**AGENDA**  
**PLANNING & ZONING COMMISSION REGULAR MEETING**  
**TUESDAY, NOVEMBER 5, 2024 - 3:30 PM**  
**MCALLEN CITY HALL, 1300 HOUSTON AVENUE**  
**CITY COMMISSION CHAMBERS, 3<sup>RD</sup> FLOOR**

1. McAllen Townsite Lot 5A Block 59 (Previously 1501 Galveston Subdivision), 1501 Galveston Avenue, Champagne & Cavaliers Investments **(SUB2024-0103) (REVISED PRELIMINARY) BE**
2. Balboa Acres Subdivision, The East Half of Lot 9 Block 27, 3409 Daytona Avenue, Ramiro A. Resendez **(SUB2024-0111) (FINAL)**
3. Balboa Acres Subdivision, The West Half of Lot 9 Block 27, 3411 Daytona Avenue, Ramiro A. Resendez **(SUB2024-0110) (FINAL)**

<b>SUBDIVISION NAME: MCALLEN TOWNSITE LOT 5A BLOCK 59</b>	
<b>REQUIREMENTS</b>	
<b>STREETS AND RIGHT-OF-WAYS</b>	
Galveston Ave.: dedication needed for 30 ft. from center for 60 ft. ROW Paving 40' Curb & gutter both sides - Provide ROW dedication as shown above prior to final. If plat remains the same, a variance application must be submitted and approved prior to final. **Subdivision Ordinance: Section 134-105 **Monies must be escrowed if improvements are required prior to recording **COM Thoroughfare Plan	Non-compliance

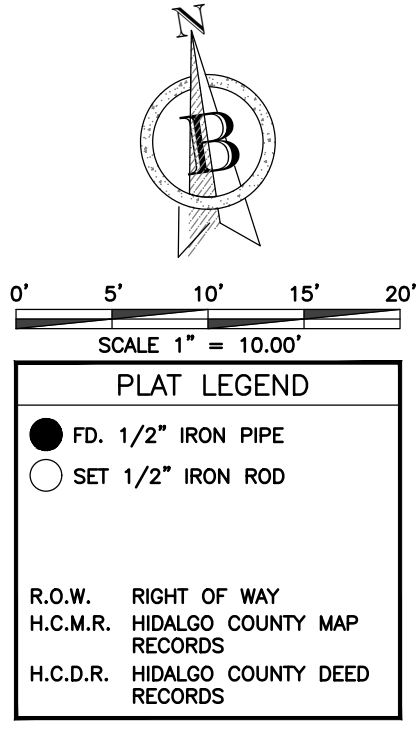
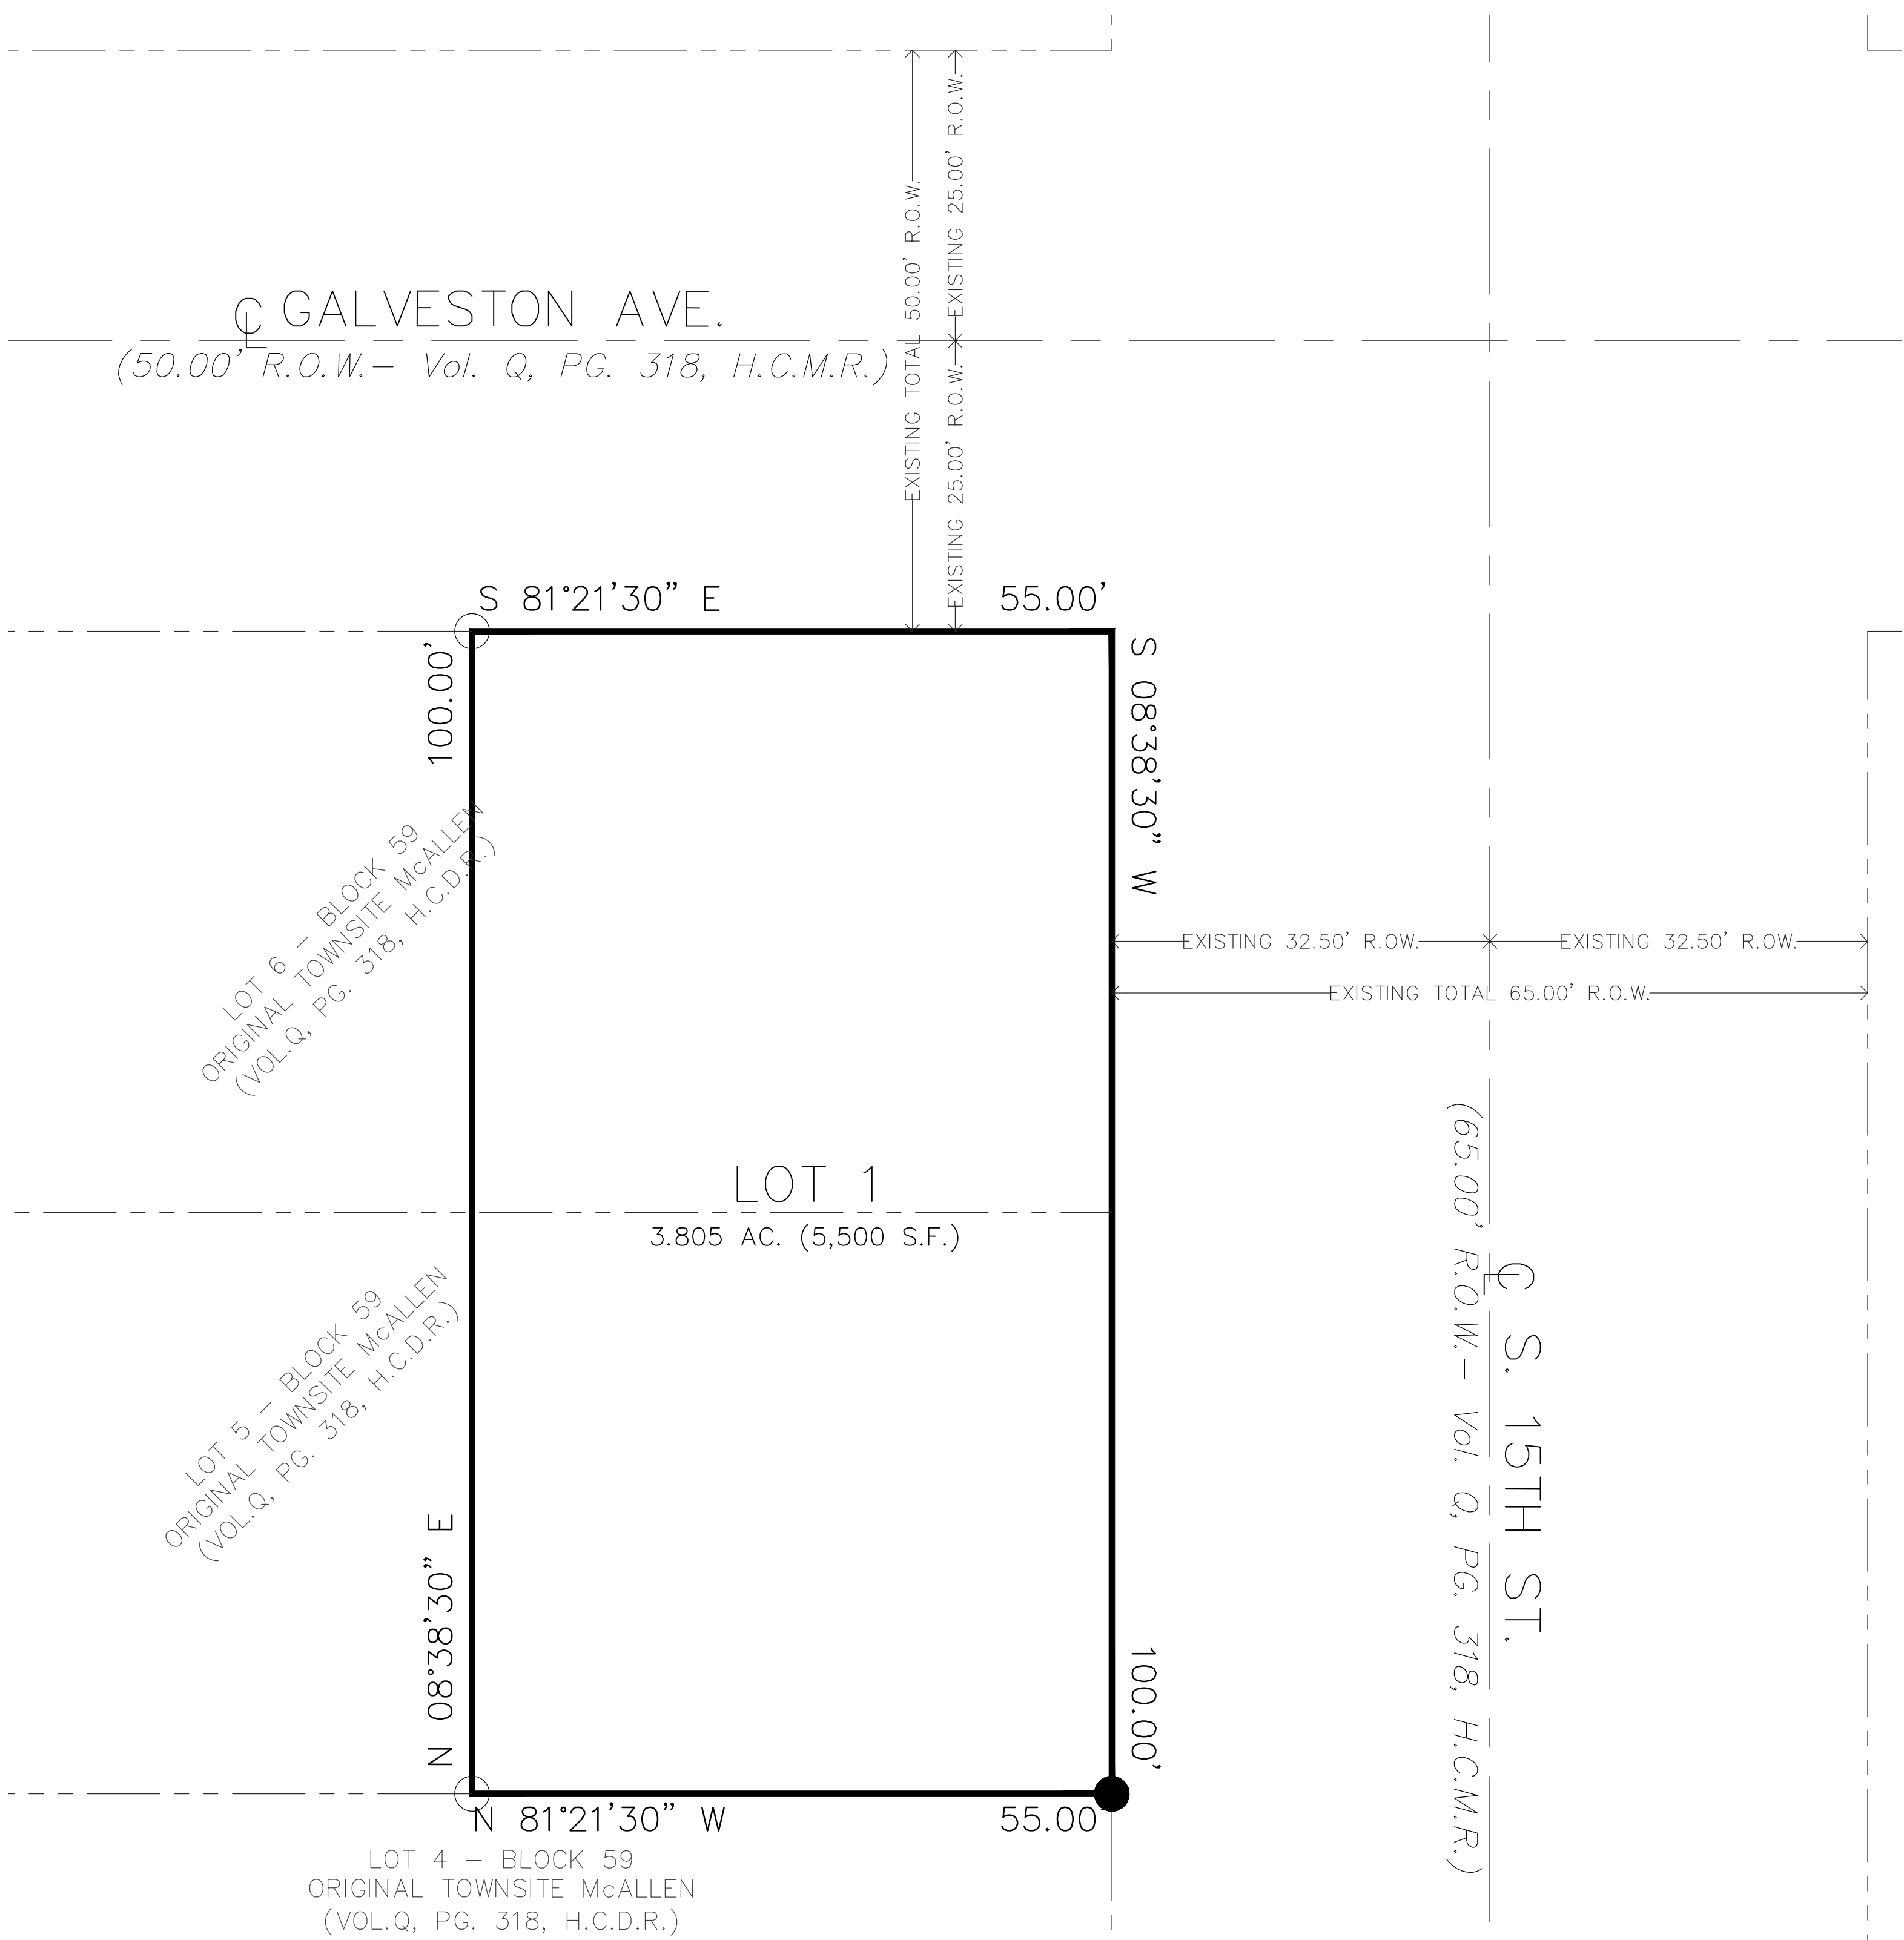
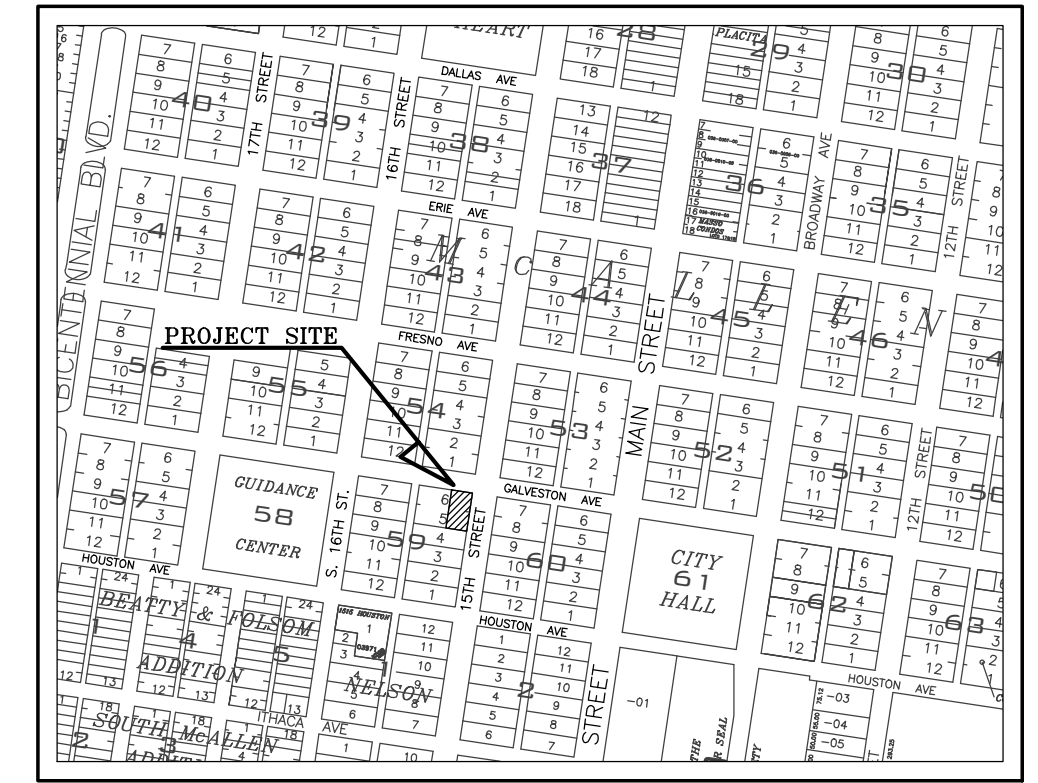
* Front - Galveston Ave: In accordance with the Zoning Ordinance or greater for easements or approved site plan, or in-line with average existing structures, whichever is greater applies. ** Revise note #4 as shown above, prior to final. **Zoning Ordinance: Section 138-356	Non-compliance

* Corner- S. 15th Street: 10 ft. or greater for approved site plan or easements ** Revise note #4 as shown above, prior to final. **Zoning Ordinance: Section 138-356	Non-compliance

* Traffic Impact Analysis (TIA) required prior to final plat.		TBD
<b>COMMENTS</b>		
Comments: *Must comply with City's Access Management Policy. - Contact the property owner of the remainder of Lots 5, and 6, on the west side to include them in the replat.		Required
<b>RECOMMENDATION</b>		
Recommendation: STAFF RECOMMENDS APPROVAL OF THE SUBDIVISION IN REVISED PRELIMINARY FORM SUBJECT TO CONDITIONS NOTED, DRAINAGE, AND UTILITY APPROVALS.		Applied
